Errata IRC Chapter 1

Code/Standard: International Residential Code

Applies to following Printings: 1st Printing

FIGURE R403.1.3

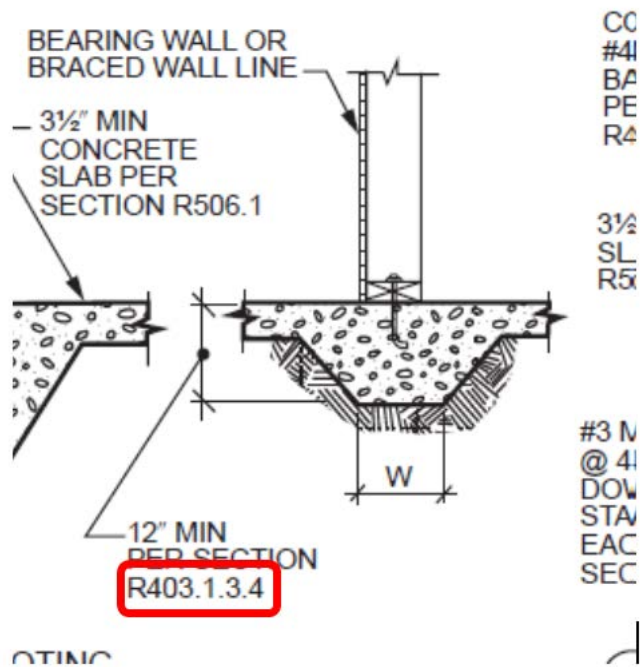
Figure R403.1.3

Section/Table/Figure Number: Figure R403.1.3

Correction:

Reinforced Concrete Footings and Masonry and Concrete Stem Walls in SDC D₀, D₁ and D₂^{a,b,c,d,e,f}

Figure R602.10.7

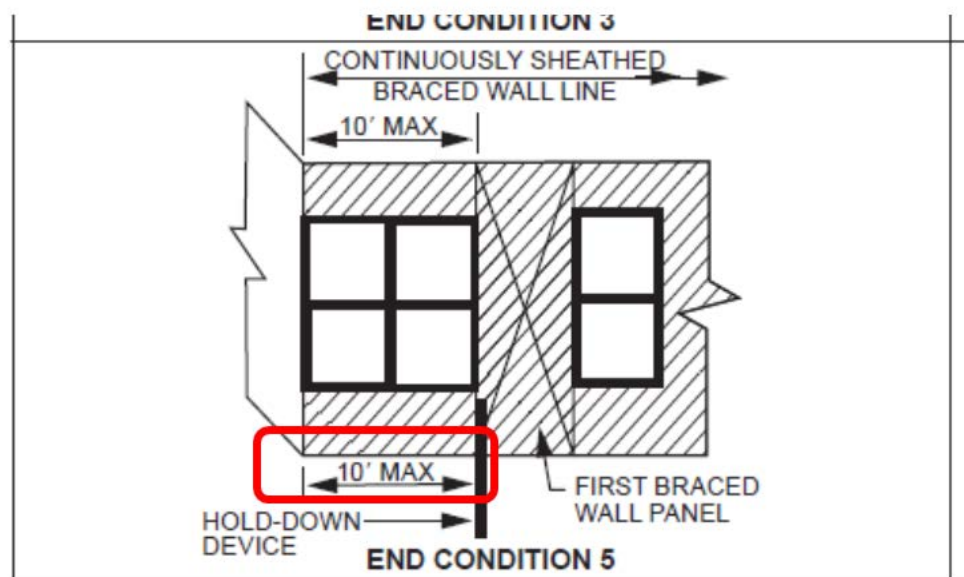
Section/Table/Figure Number: Figure R602.10.7

Correction:

Figure 802.4.5

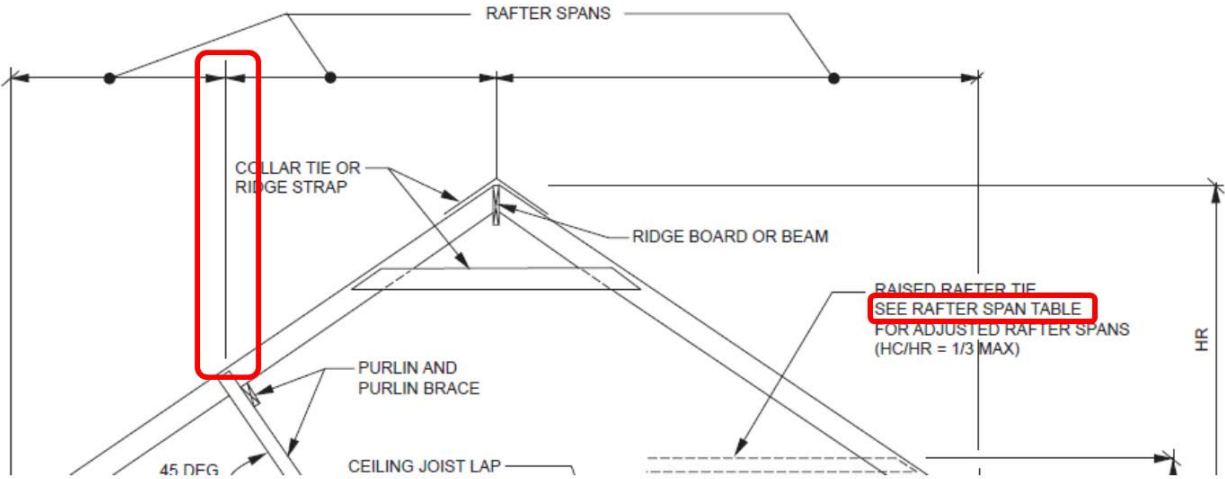
Section/Table/Figure Number: Figure R802.4.5

Correction:
